Market Ancillary Service Specification Consultation - May 2022

Organisation:	Evergen Pty Ltd
Contact name:	Stephen Pritchard
Contact title:	Senior Electrical Engineer
Contact details:	stephen.pritchard@evergen.energy

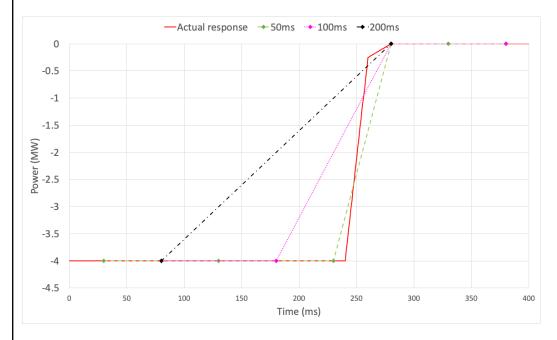
Fig. 3.5 from the UoM study depicts how worst-case underestimation errors might occur based on the timing of samples. Evergen includes here a different sampling timing to indicate how close to worst-case **over**-estimation might occur for low sample rates:

It seems intuitive that a large over-estimation might occur in the worst case similar to the under-estimation worst case, especially for the 200ms sampling rate case. And yet the bias towards underestimation is apparent in UoM's results.
